TITLE TECHNICAL BULLETIN, HOUSING REPLACEMENT FOR S200 SWITCH			
SIZE A	CAGE CODE 12522	DWG NO TB-228	REV 1.0
SCALE NONE	WT	SHEET SHEET 1 OF 3

## 1.0 PURPOSE

**Figure 1**

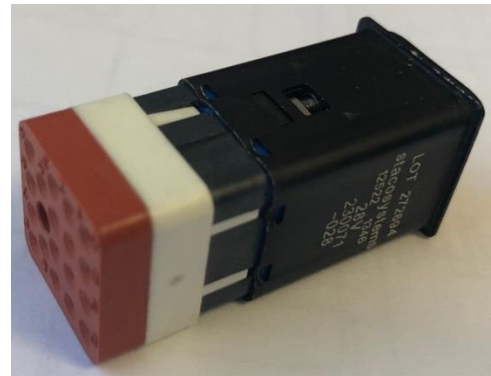
The purpose of this technical bulletin is to provide information regarding the S200 crimp terminated housing change. Staco Systems replaced the extended housing (reference Figure 1) with a short housing (reference Figure 2). This change does not affect fit, form or function of the crimp version of the S200 switch assembly.

All S200 Switch coded part number as shown above with a date code of 1846 or higher shall have the short housing as shown in Figure 2.
